**Sub:** Diversion of 0.4928 ha. of forest land in Sy. No.215A1A, Arav village, Savanthawada Hobli, Karwar Taluk, Uttara Kannada District for establishment of Building Stone Quarry and its approach road in favour of M/s. Sai Ram Enterprises, Gaongeri, Majali, Karwar. (Proposal No. FP/KA/QRY/46423/2020)

## SITE INSPECTION REPORT

## **Recommendation of DDGF (Central) Regional office, MoEF&CC, Bengaluru**

### Existing Road/Proposed Approach Road towards Quarry Site

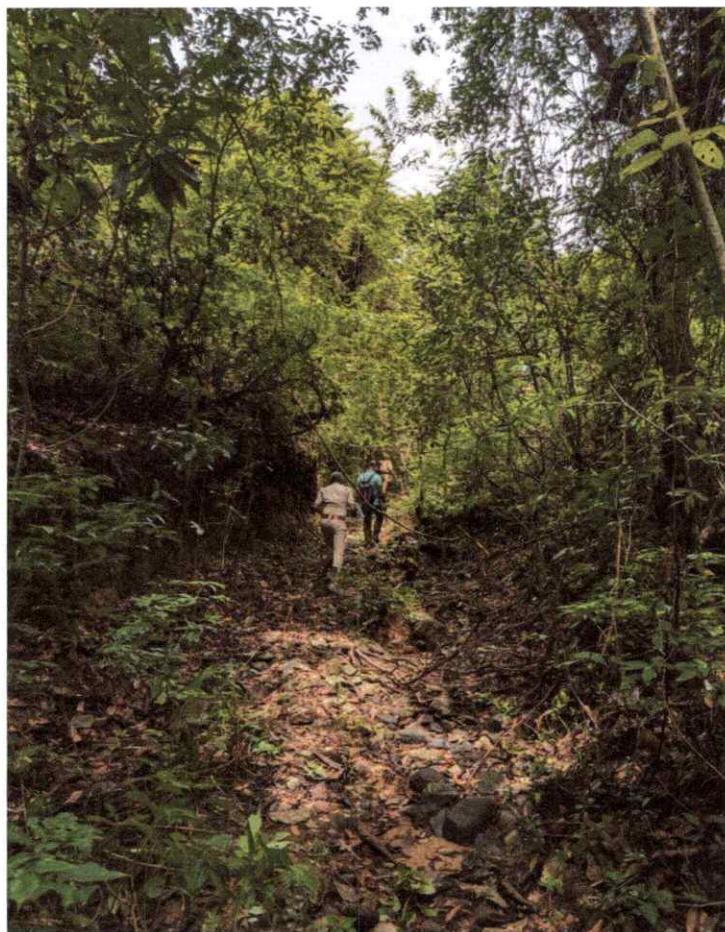
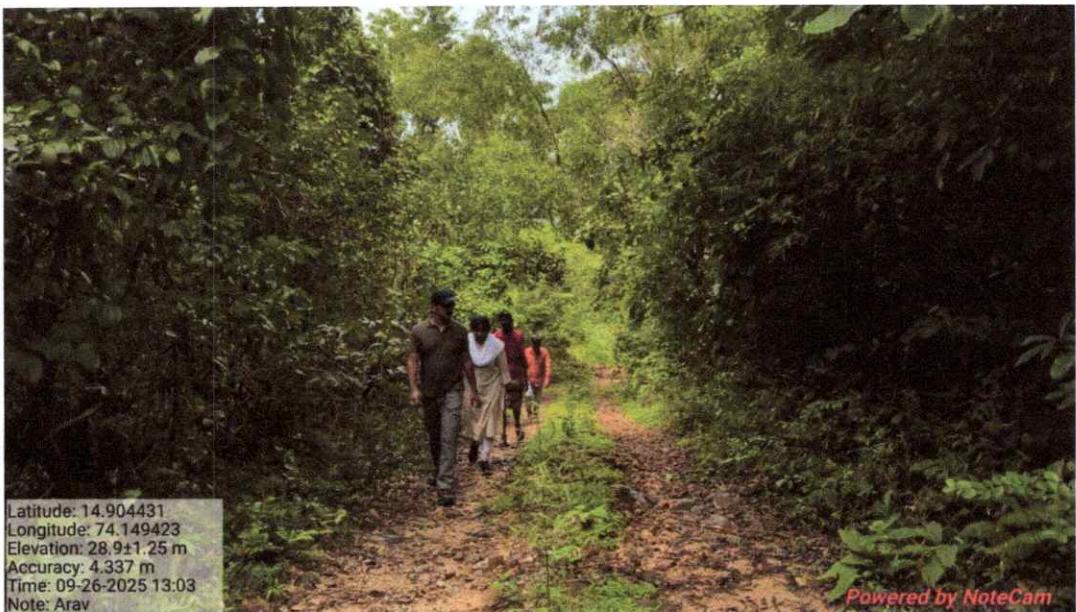
2. The proposed approach road now is in series with another road proposal submitted vide proposal No. FP/KA/ ROAD/16625/2015 and therefore, mutually entail implications another Chapter-5 of FC guideline regarding multiple users. Moreover, in the earlier proposal, it was reported that local public also use that road whereas it is not clear whether the current road also involves such use. The State Government should have linked both proposals in terms Chapter 5 and processed.

1. The area proposed for quarry is starting from the already extracted quarry edges. It was informed by the UA that quarry was running since 1984 and stopped during 2010.
2. Quarry area was not demarcated in the field.
3. Proposed quarry site is having canopy density of

The approach road proposed in this proposal is not connected with another proposal submitted by different user agency. The road that have proposed too lead from private land having Sy.No: 203/A1 of Arav Village, Karwar Taluk to proposed quarry site. Further, Government of India vide letter No. 4-KRB1392/2022-BAN/969 dated 18-11- 2022 had rejected the proposal No. FP/KA/ ROAD/16625/2015.

**Excavated area from where proposed quarry site begins**

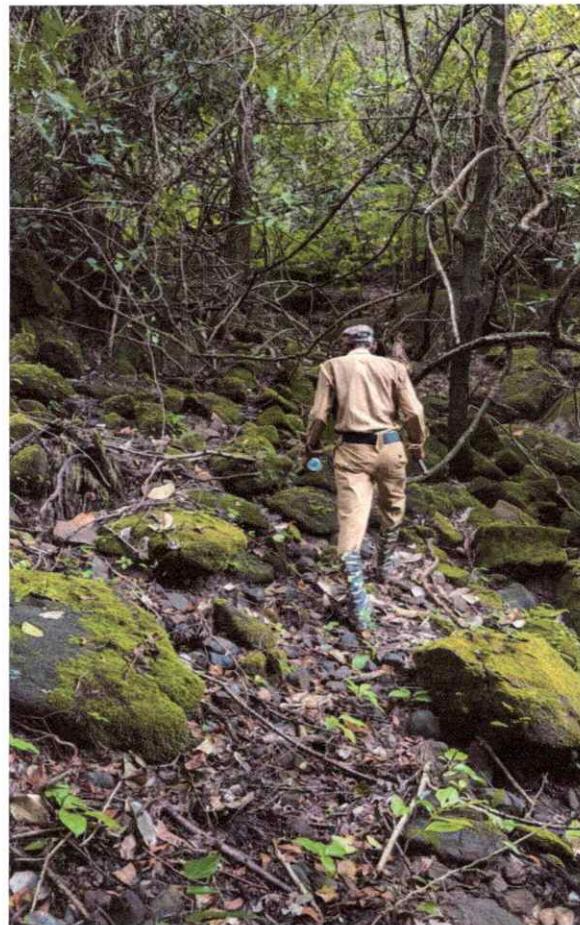
9.	Whether the proposal involves violation of the Forest (Conservation) Act, 1980 or not. If yes, a detailed report on violation including action taken against the concerned officials:	Yes. During Site Inspection it is noted that the proposed area for quarry starts from the already quarry extracted parcel for which there were no forest clearances under the V(SES) Adhiniyam Act, 1980. In 1984 temporary permission by the state government (DCF) was given for only 45 days but extraction of stones and later in 1994 temporary permission was given by CF Karwar. As stated by UA during 2010 quarry was stopped. It is to note that no forest clearance given under V(SES) Adhiniyam Act, 1980.
